Memorandum
 Planning and Urban Development Department
 Planning Division

To: Sean Dundon, Chair, and Members of the Portland Planning Board
From: Shukria Wiar, Planner
Date: October 5, 2018
Re: Spectrum, 70 Johnson Road
Project #: 232-2018 **CBLs:**
Meeting Date: October 9, 2018

Figure 3: Site Plan of Phase I

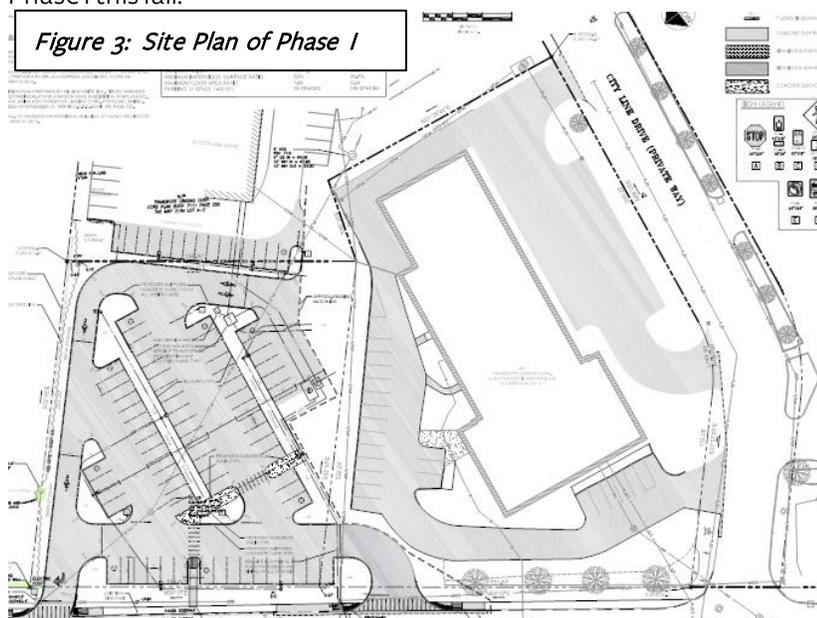
Status: The current driveway configuration for the Phase 1 Parking Lot is not acceptable. A restricted right-turn entry/exit driveway may be permitted, but additional review is required.

Status: This item is likely not an issue in Phase 1 with a possible turn restriction driveway. Further review is required.
